Review Comments of the “Evaluation of Sediment Transport Data for Clean Sediment TMDL’s as prepared by Roger Kuhnle and Andrew Simon in ARS Report No. 17 of November, 2000.

**By
Dave Rosgen, P.H.**

Figure 1. The hierarchy of river inventories showing various levels of investigation (from Rosgen, 1996)

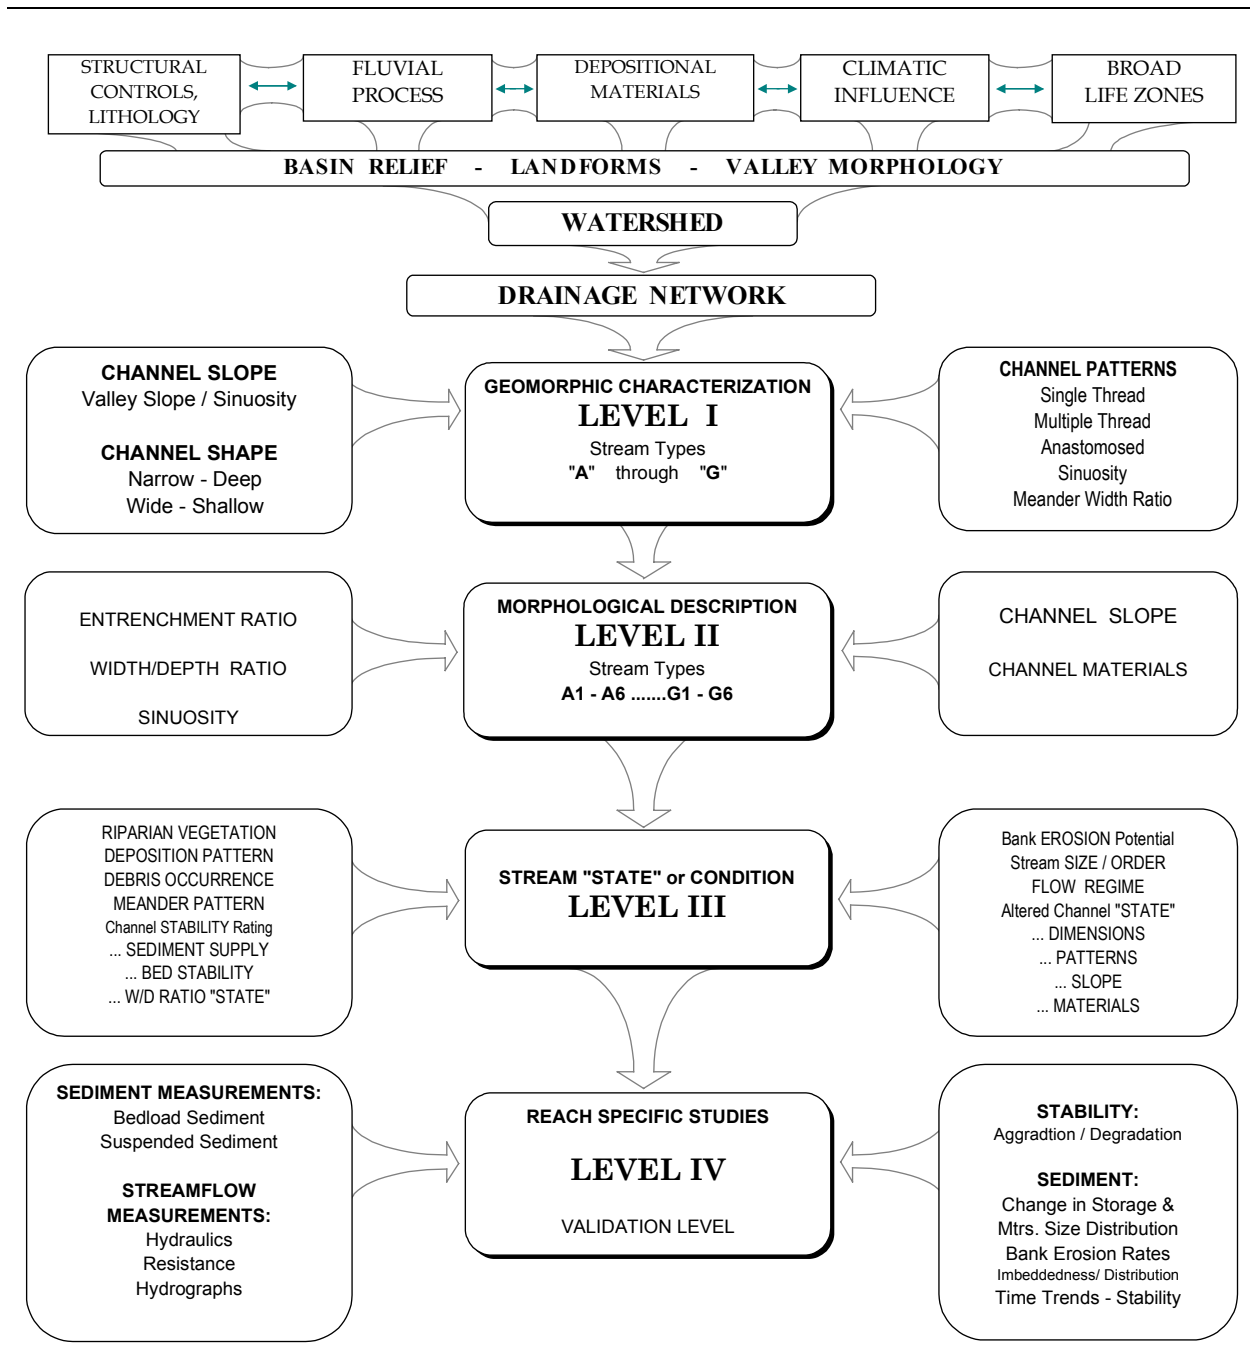
Page 5. There is a misunderstanding of the stream classification system based on the statement that gradient, as a delineation variable is included to a **lesser degree**. This is **not true**. Gradient is a critical variable and is included at the initial level of delineation (Level I). Level I does not include particle size, however, the level appropriate for this purpose in level II, includes channel materials. The processes of channel form influenced by sediment are integrated into the morphology of rivers described by stream type, yet changes in sediment supply (availability) have to be identified more specifically by stability analysis (level III, Figure 1). This fact seems to have been overlooked in the discussion in paragraph three and four.

Figure 4. Application of channel evolution model (qualitative) to a morphological stream classification system (quantitative) (from: Rosgen, 1999)

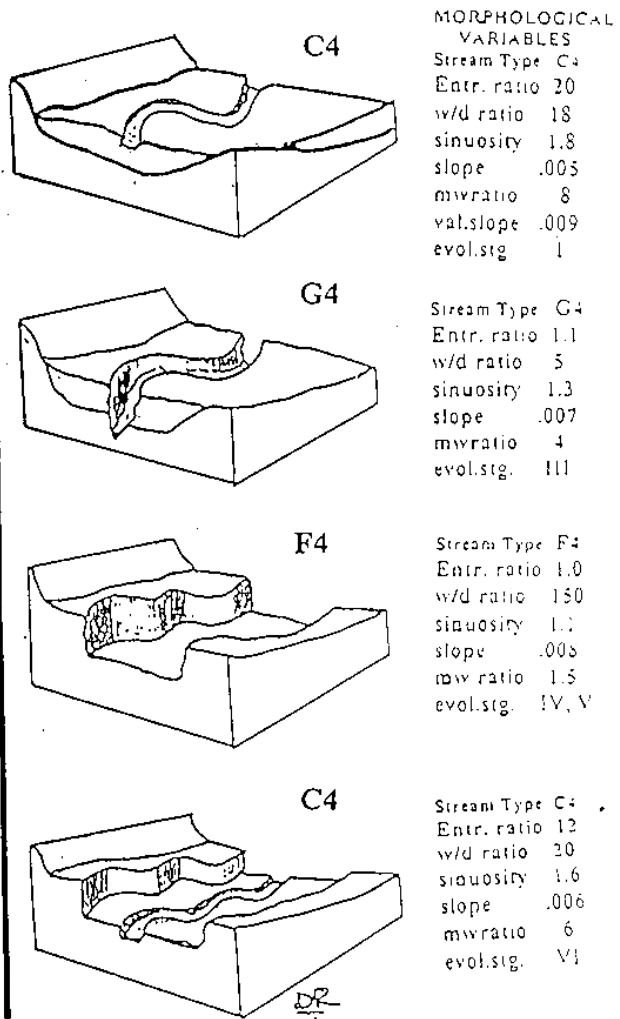
I agree with the use of a channel evolution sequence. I have referenced similarity between quantitative relations of changes in morphology associated with various stream types with the channel evolution model by Simon and Hupp, (1986) in an AWWA paper (Rosgen, 1999), Figure 4.

Troendle and several biometricians conducted statistical analysis involving over 160 rivers with concurrent suspended sediment measurements, bedload measurements, hydraulic data, stream classification, and stream stability where over 320 models were tested. One of the results (that could have been shared with the authors had they communicated with either Troendle or myself) showed a significant shift in the dimensionless sediment rating curve due to changes in stability comparing poor versus good/fair stability ratings using the Pfankuch rating procedure. Stream type, by itself did not show significant departures in the dimensionless suspended and bedload rating curves. Based on the previous discussion, without a stability analysis, stream type alone was never intended to infer stability and corresponding dimensionless ratio sediment rating curve shifts, unless the instability resulted in stream type shifts (as in the C4-G4-F4 discussion, Figure 4).

Figure 7. Various stream type evolution scenarios

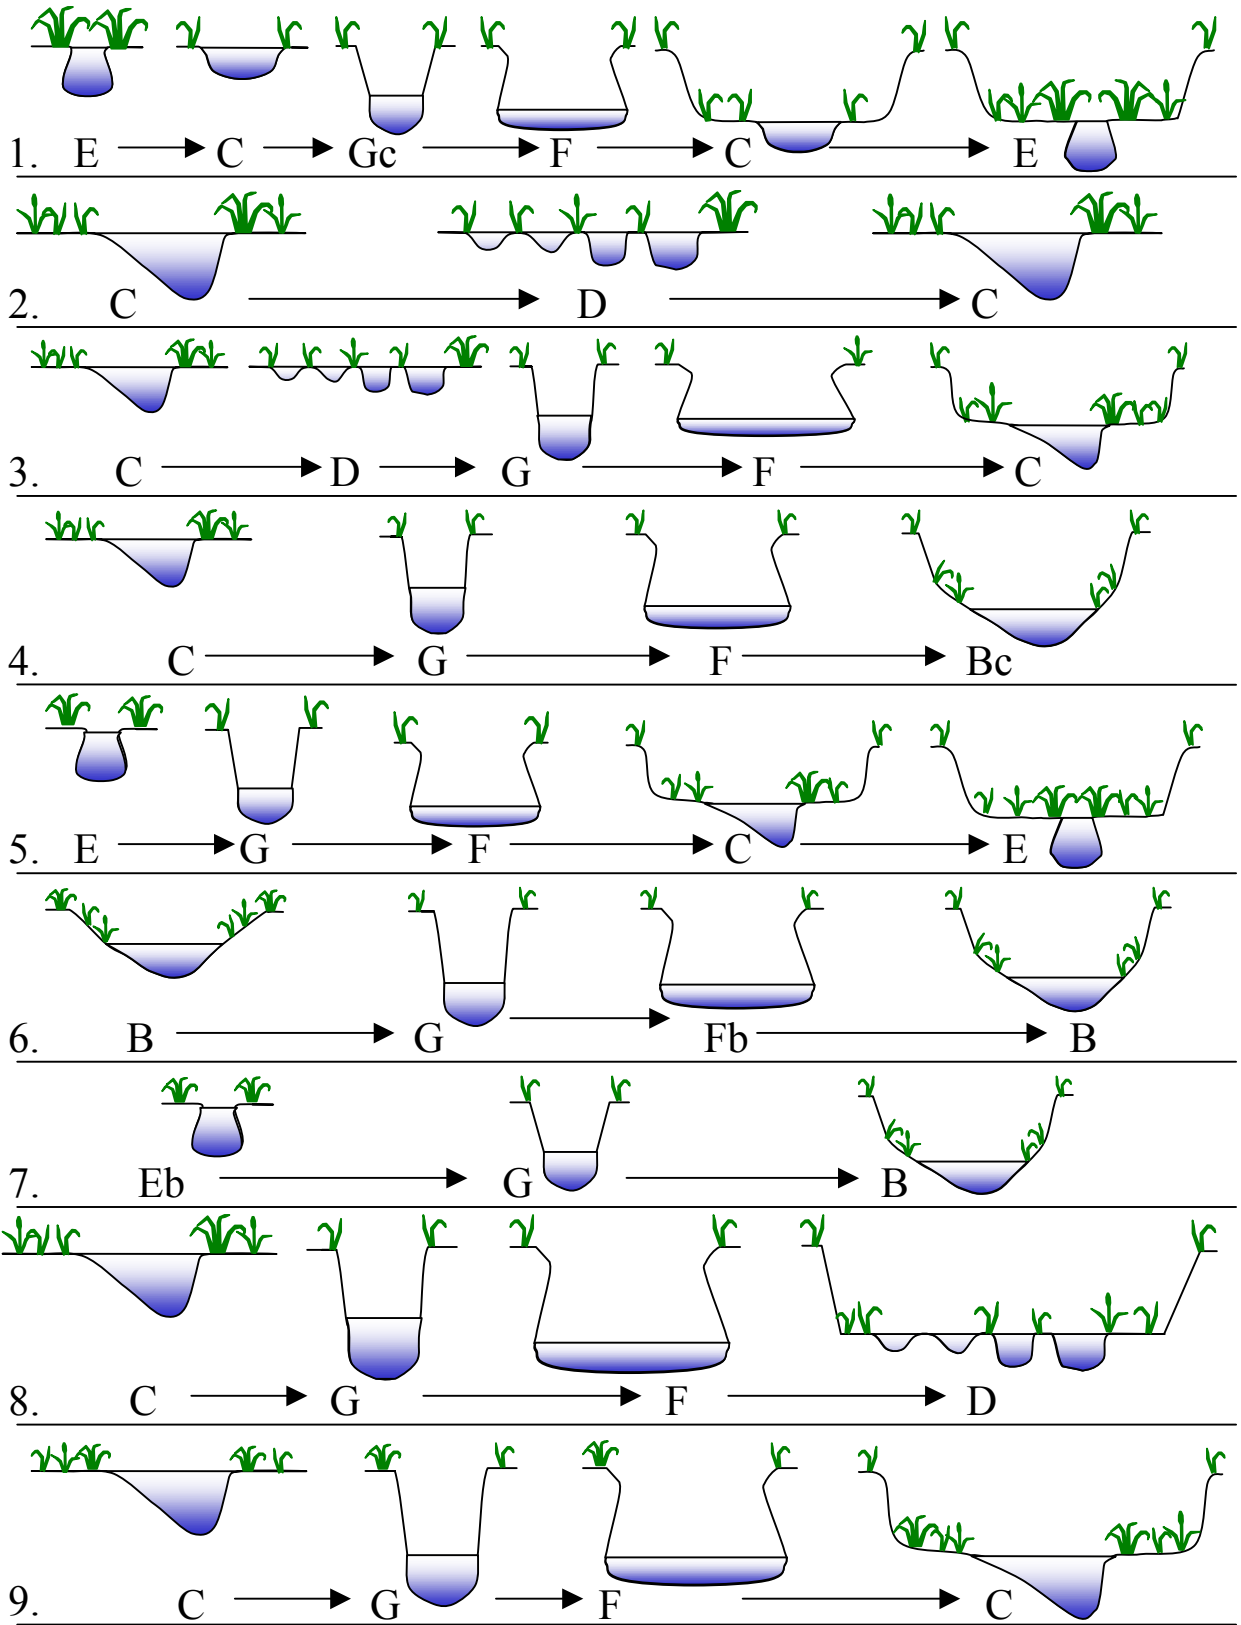
Page 15. How would the channel stability index be used to relate to sediment supply/sediment transport data? It is not a correct assumption that the channel evolution model (Stage I-VI) is appropriate for all altered streams. I agree with the six stages you describe for incised river systems, but there are many other scenarios that need to be included (Figure 7).
